Re: Memorandum Dated July 13, 2015
Draft Foundation Investigation Report
Agreement # 5013-E-0033, Assignment # 8
Spanish River Bridge Rehabilitation, Site No. 46-161
GWP 5251-10-00, HWY 6

The comments provided by MTO on the review of delivered items have been addresses as follow in green color and underlined text:

**FOUNDATION INVESTIGATION REPORT
SPANISH RIVER BRIDGE - HIGHWAY 6
TOWNSHIP OF MERRITT, SUDBURY DISTRICT
AGREEMENT NO.: 5013-E-0033
ASSIGNMENT NO.: 8
SITE NO.: 46-161
GWP 5251-10-00
GEOCRES NO.: 41I-335**

RECORD OF BOREHOLE No BH2

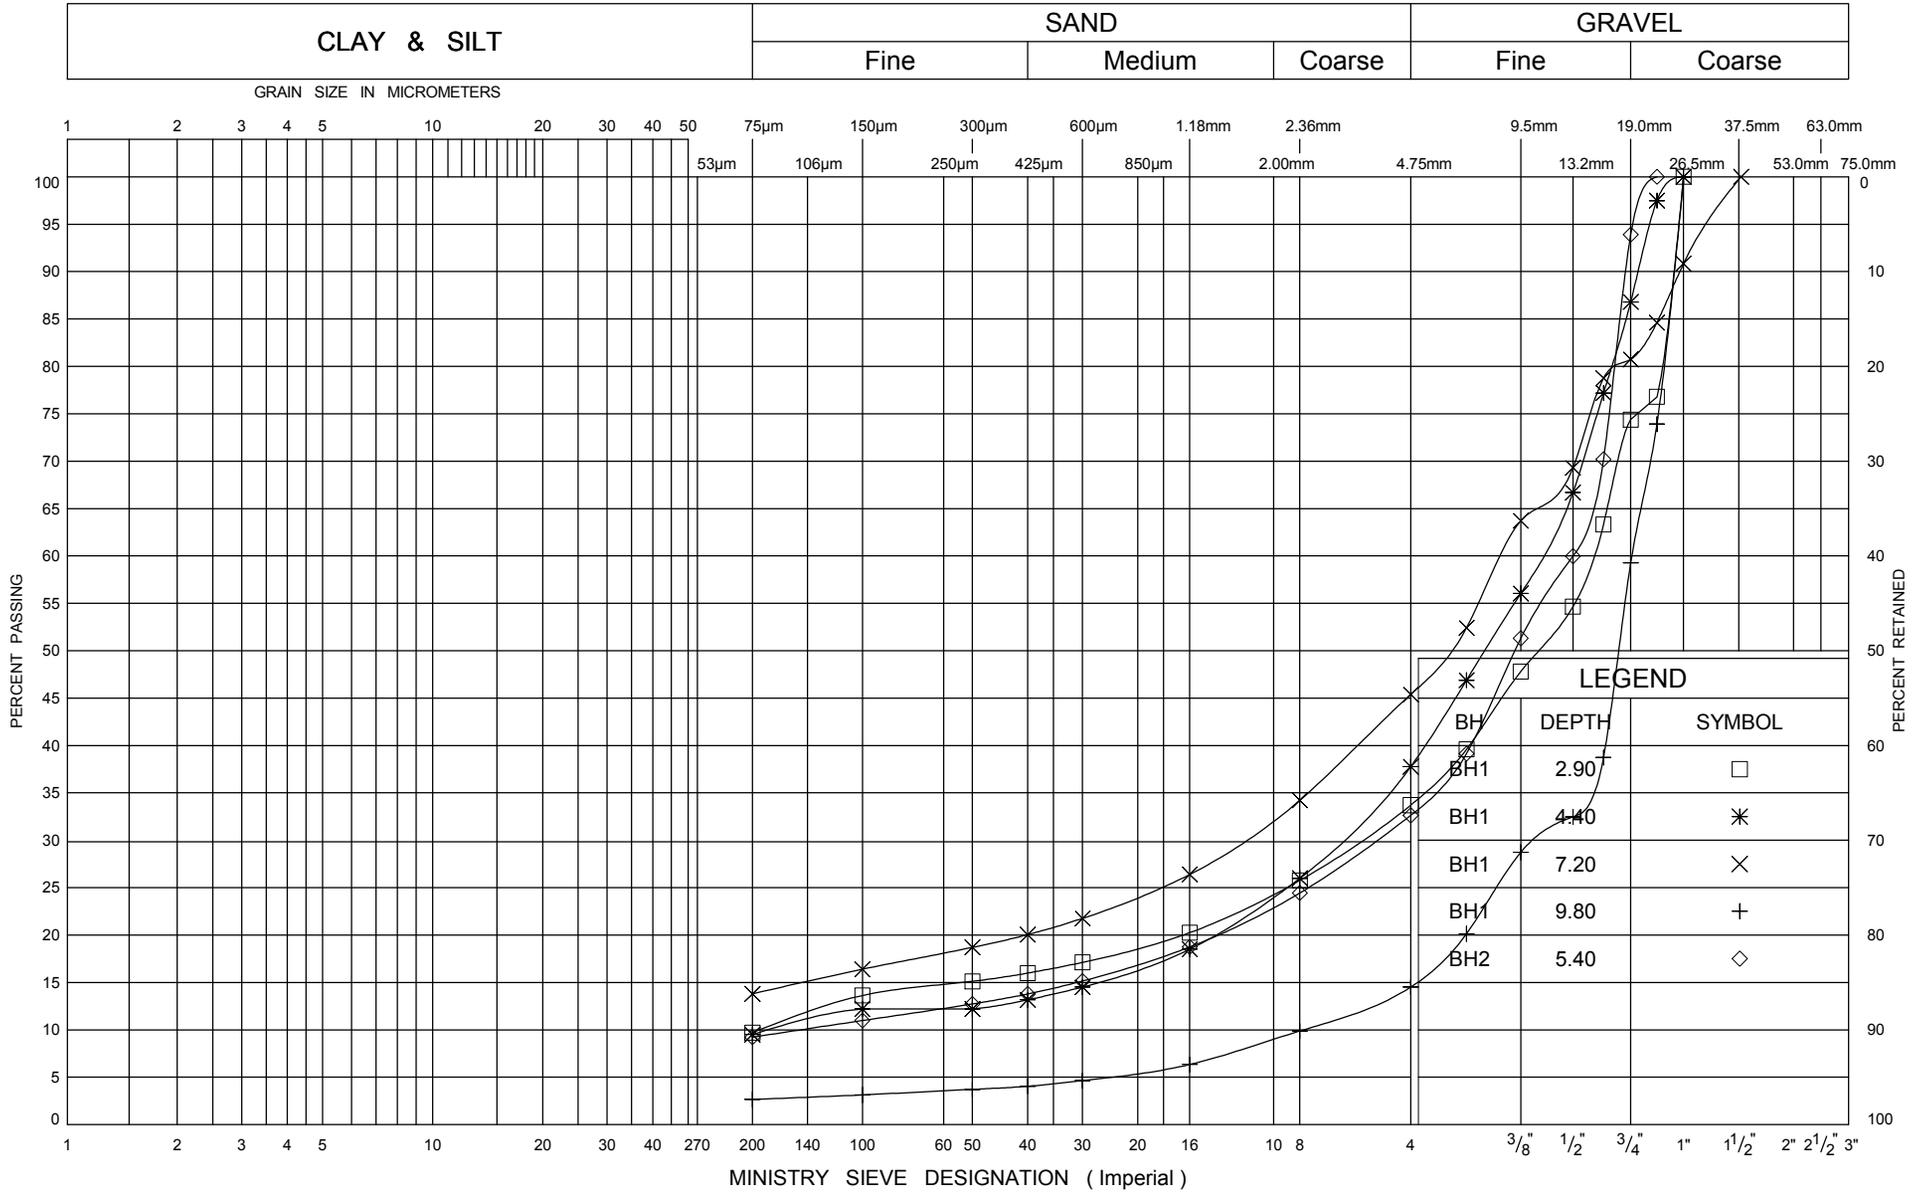
12. **Borehole 2 log:** As a general comments for all the layers encountered in this borehole, where cobbles and boulders were encountered, please make a separate statement indicating cobbles encountered/boulders encountered at the corresponding elevation where cobbles/boulders were encountered. Also, please indicate if the borehole was dry upon completion or otherwise indicate the water level.

A separate statement was made indicating cobbles encountered/boulders encountered at corresponding elevation where cobbles/boulders were encountered.
